ADDENDUM NO. 6

Project Name: Indian River County Fire Station 7 (IRC-1911)

Bid Number: 2024041

TRUCK TURN PLAN & FIRE FLOW TEST

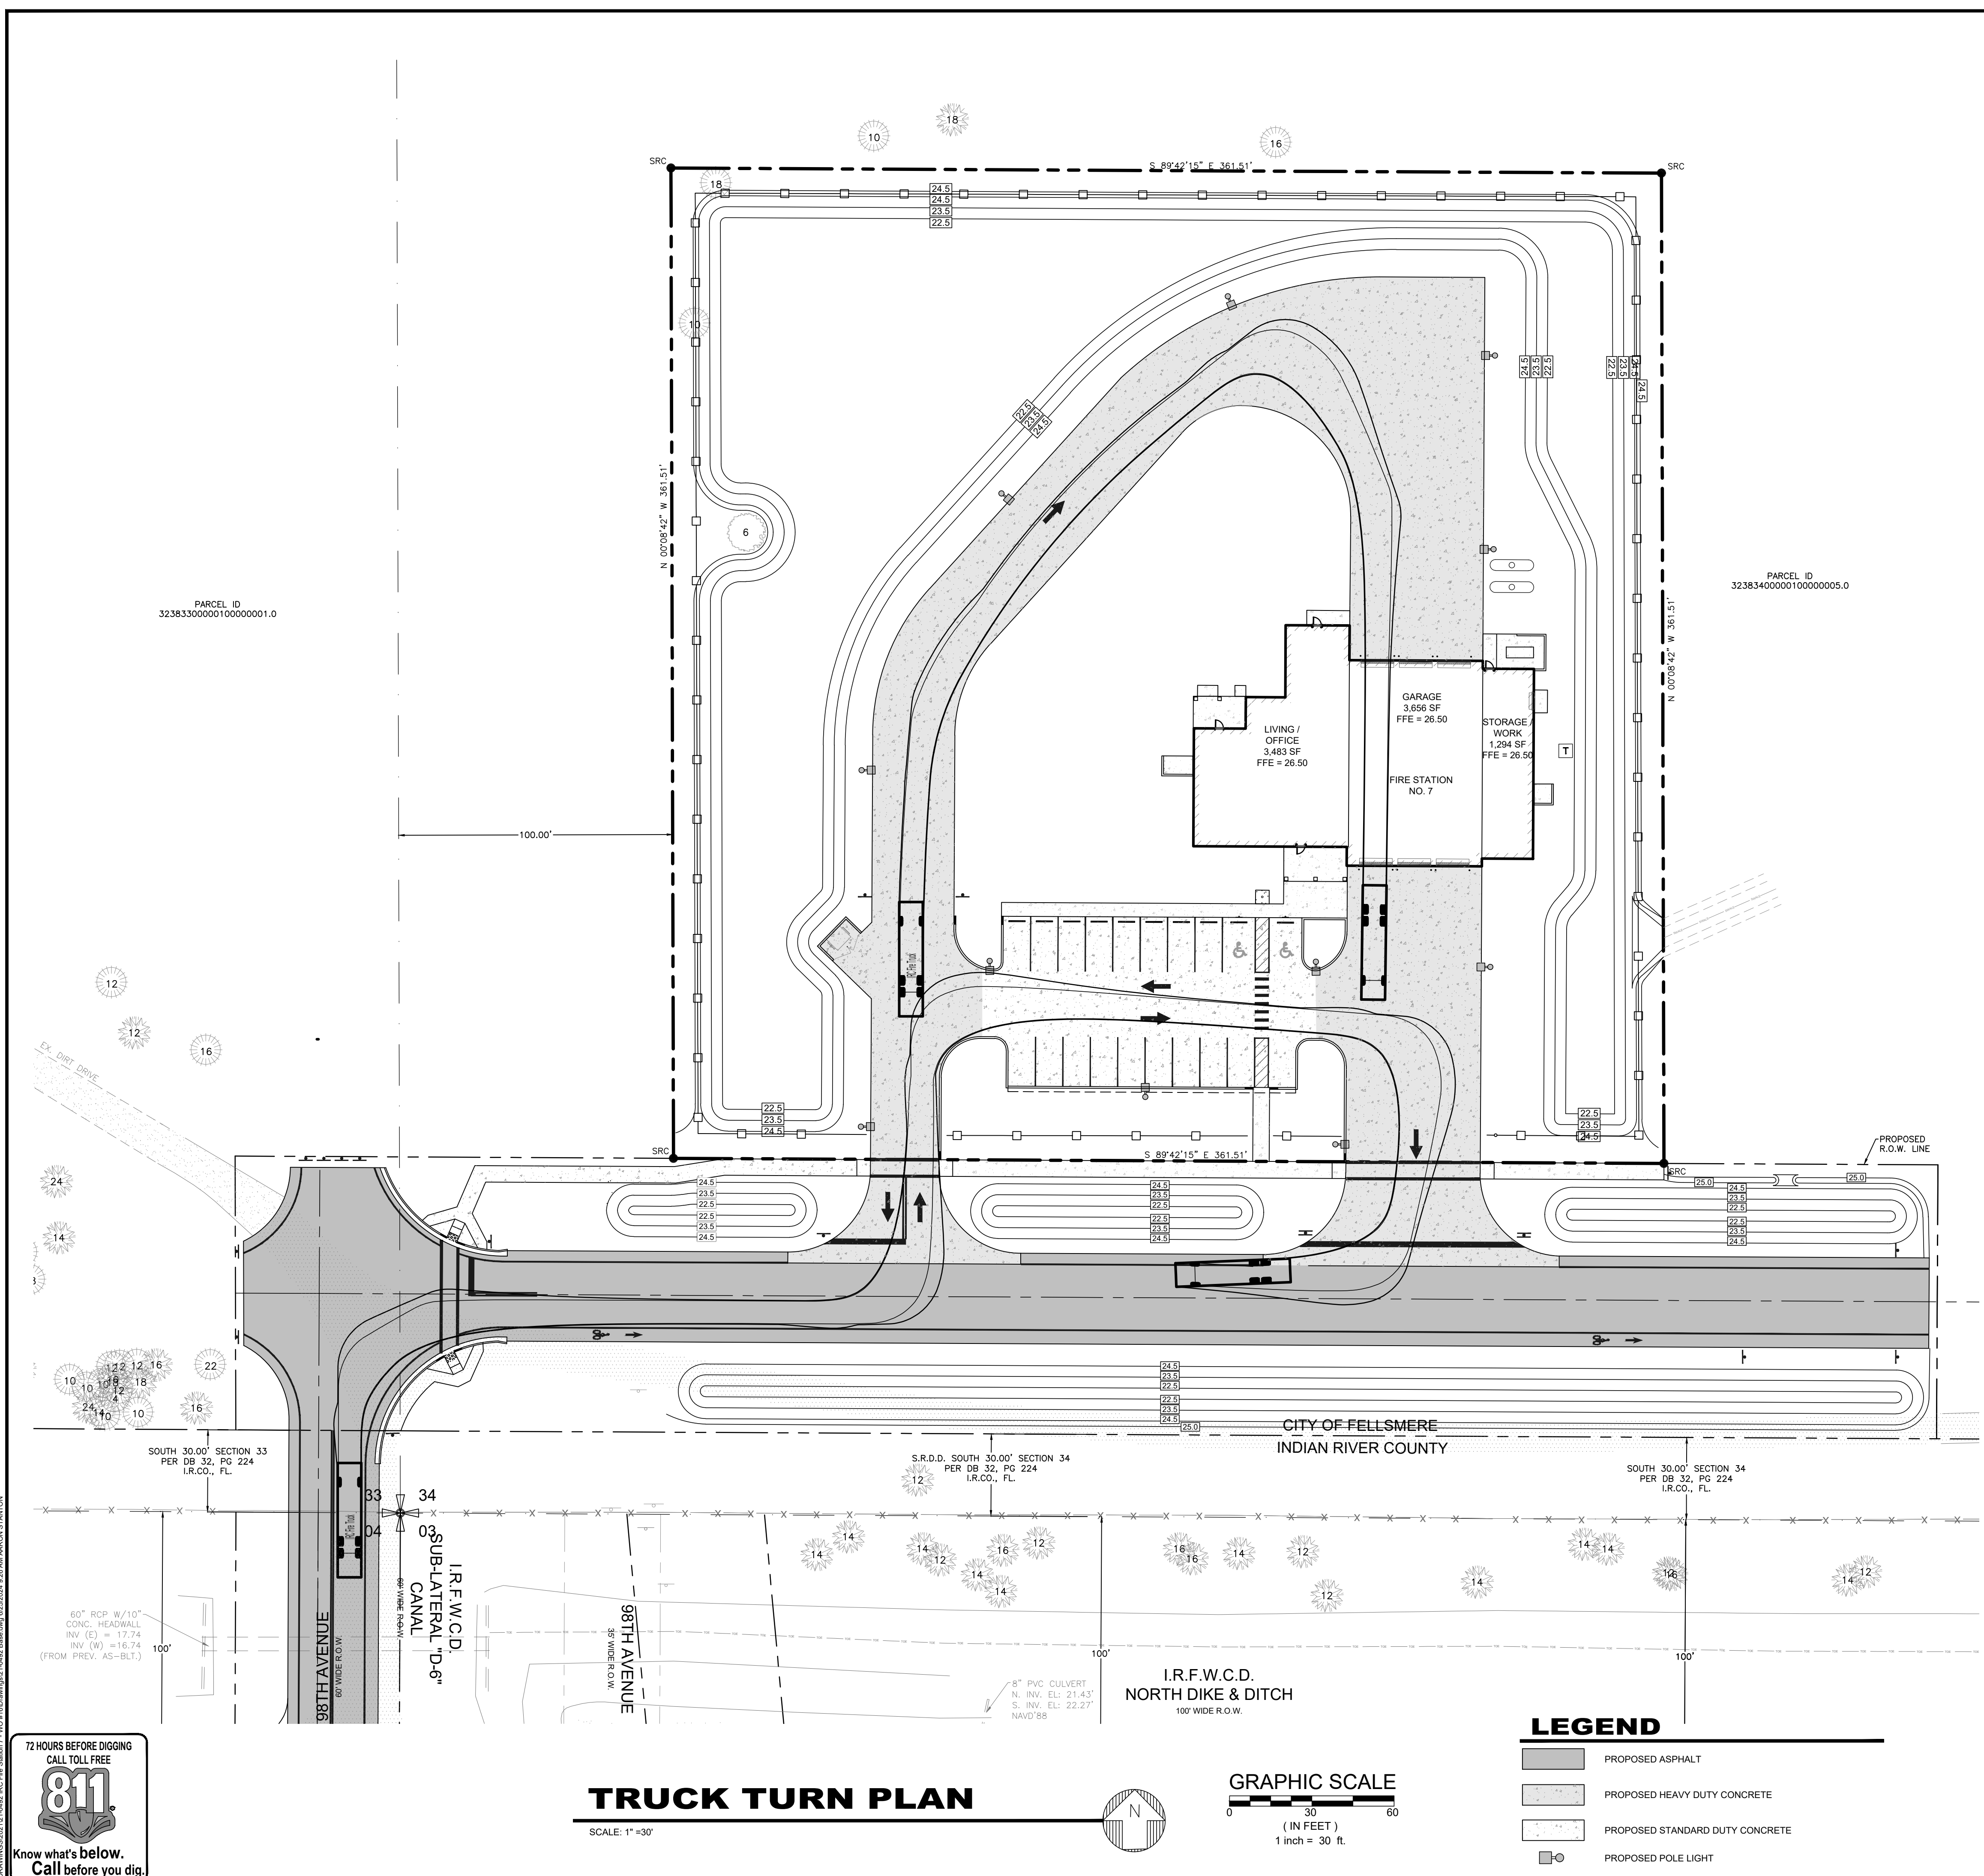
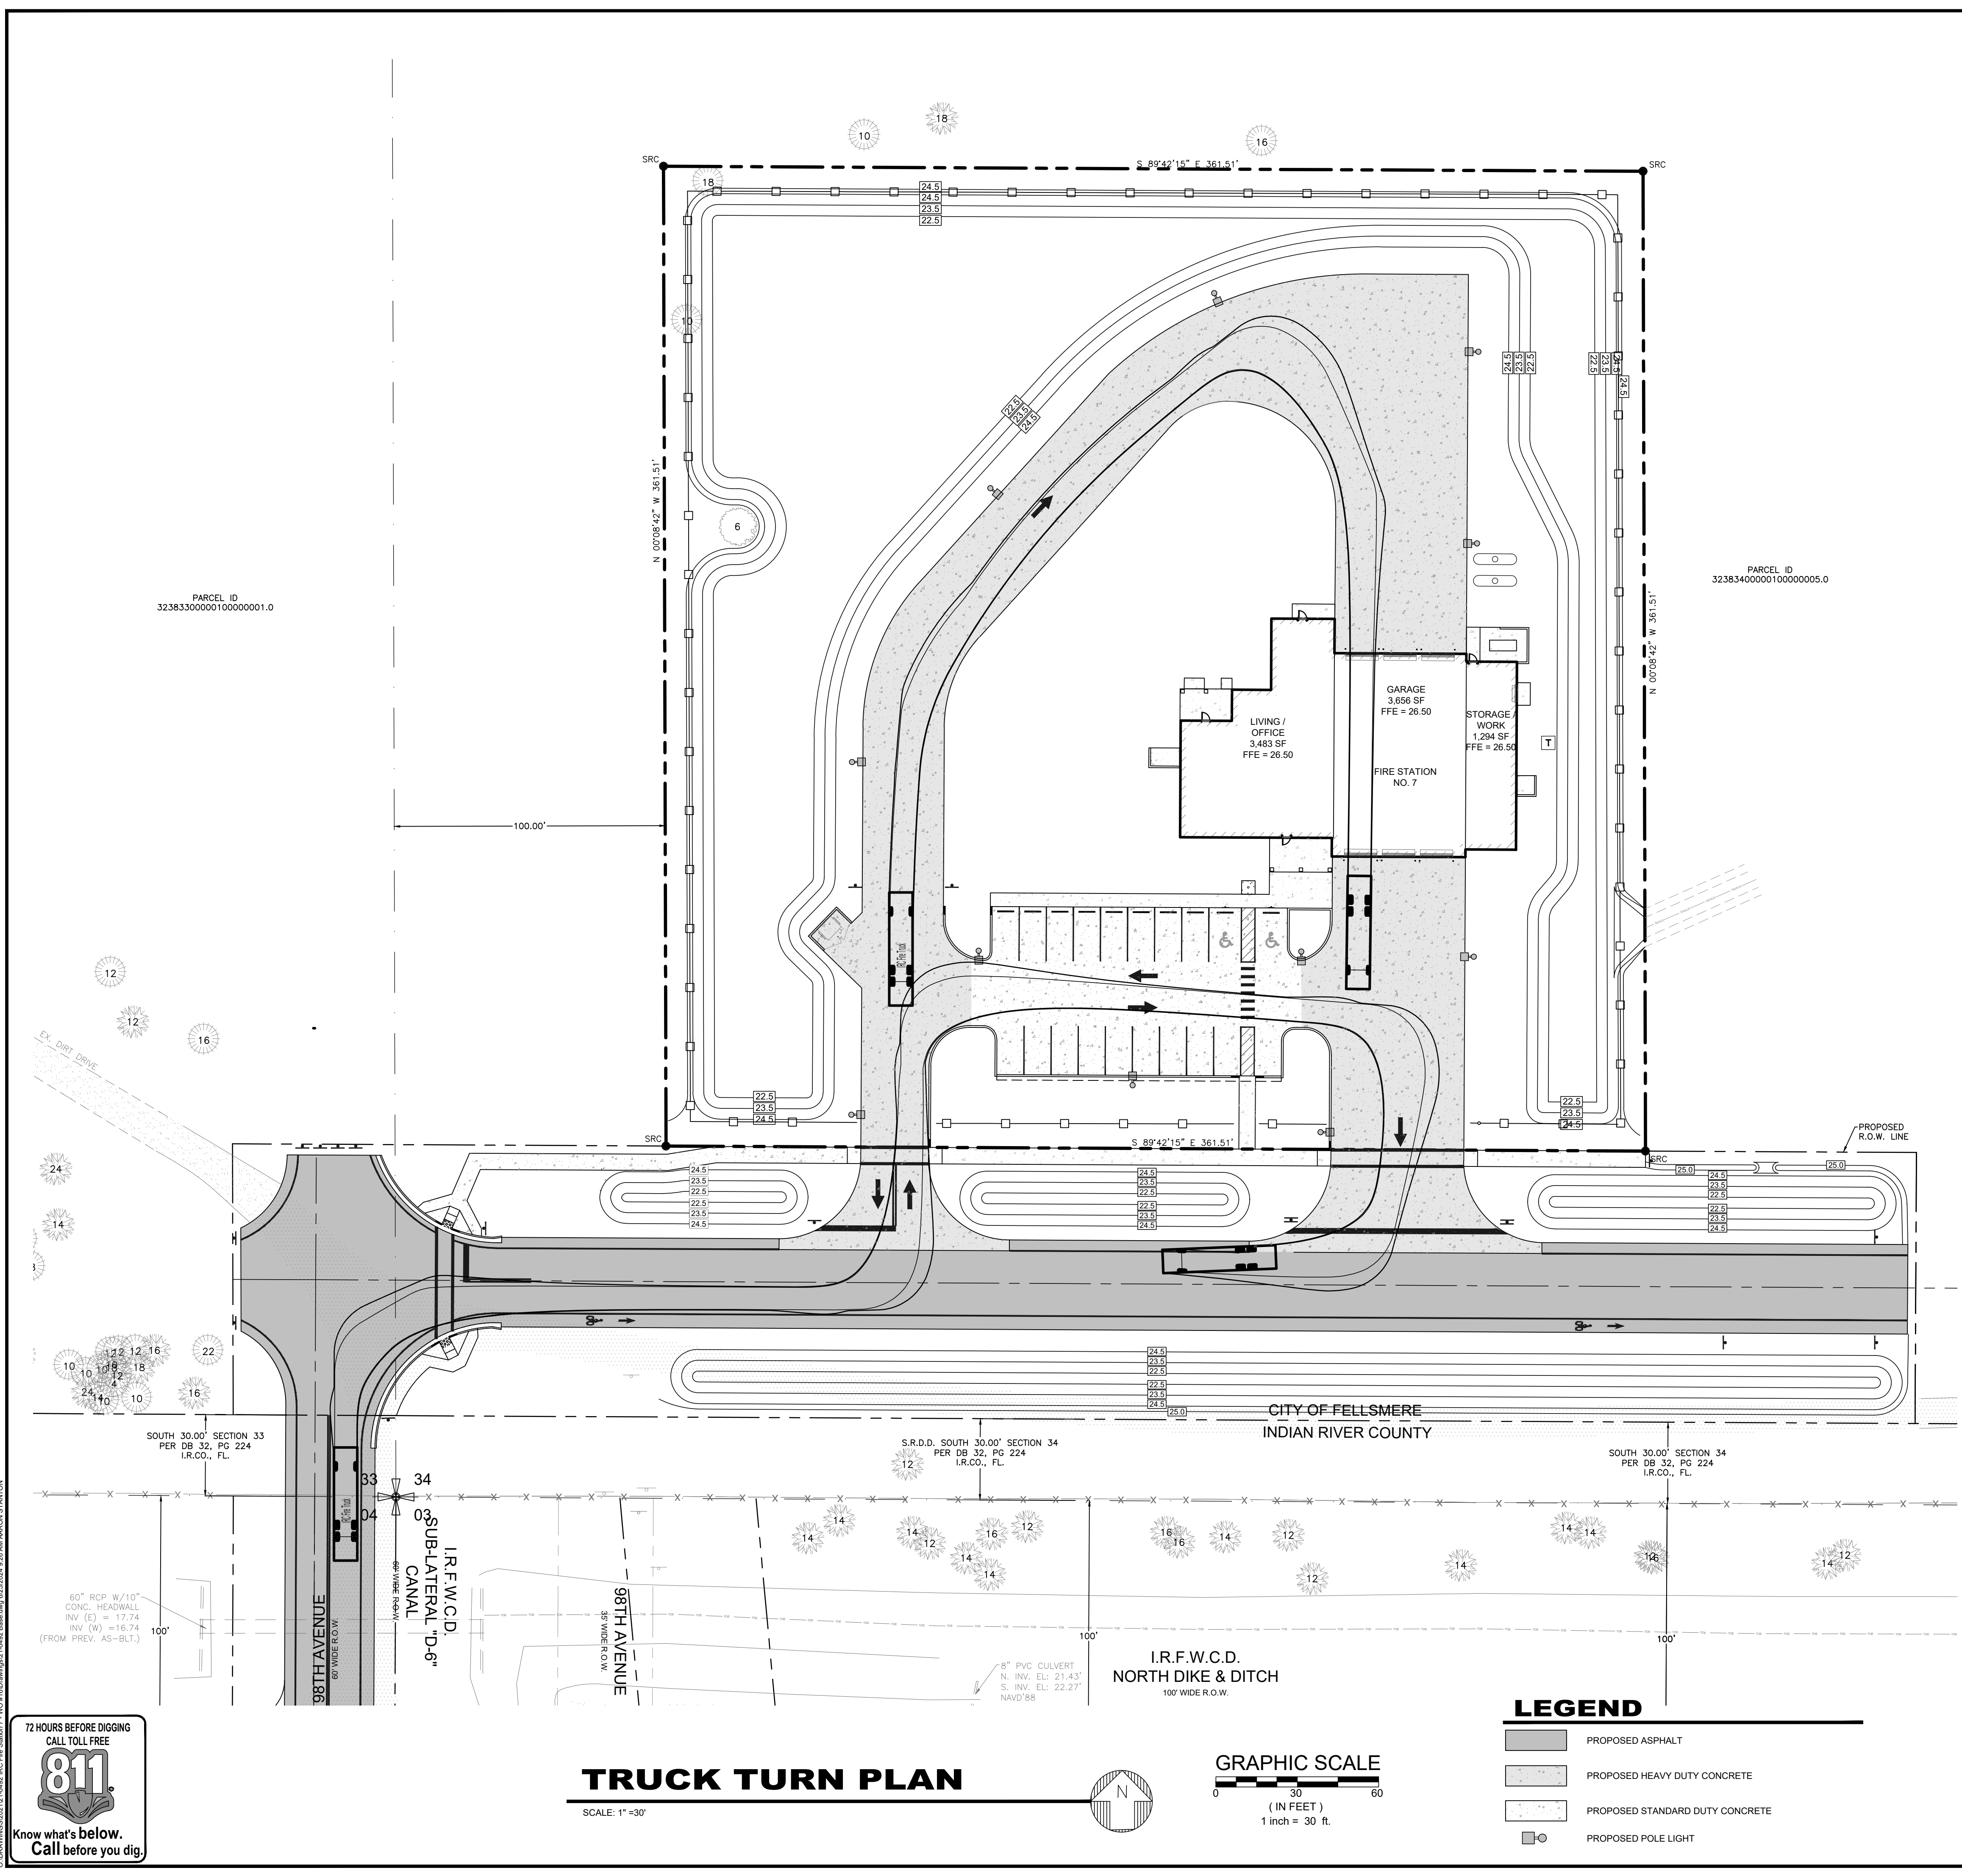
4. Can you please provide us with the EX1 Truck Turn Plan - Hydrant Flow Test, as it is missing in the plans.
See included plan – one set signed and the other unsigned to assist in quantity takeoffs.
